Expansion Tank, Installation
CHU, CXU, GU, TD, PI, GR

FSB 261-040, Expansion Tank, Installation

(May 2018)

Expansion Tank Fastener Guide

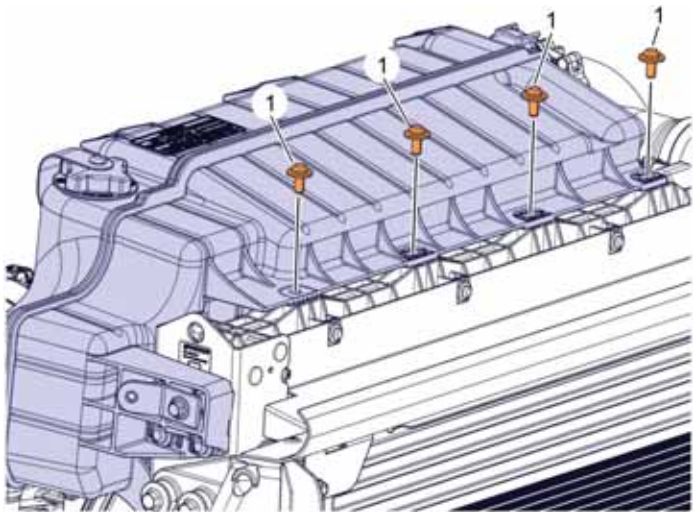
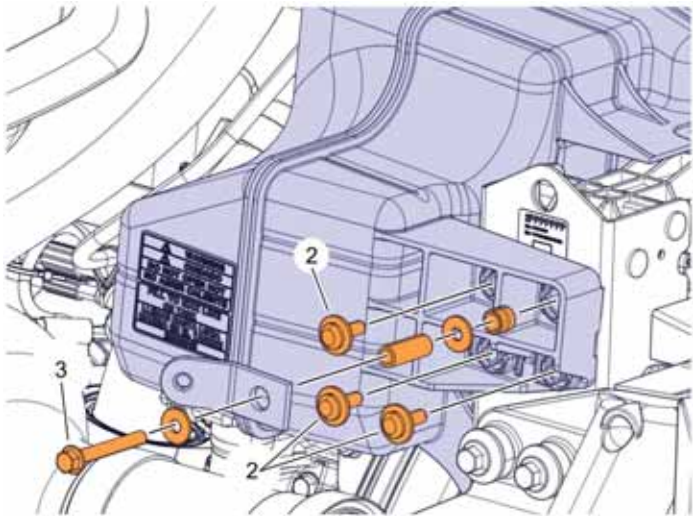
The expansion tank mounting fasteners must be installed in the same position they were removed from. Failure to install M8*20 mm, M8*25 mm, and M8*60 mm fasteners in the correct location could pierce the radiator and cause it to fail. Follow the fastener installation instructions outlined in this Field Service Bulletin (FSB).

Expansion Tank Fastener Guide			
Item	Description	Size	Qty
1	Flange Screw	M8* 20 mm	4
2	Flange Screw	M8* 25 mm	3
3	Flange Screw	M8* 60 mm	1
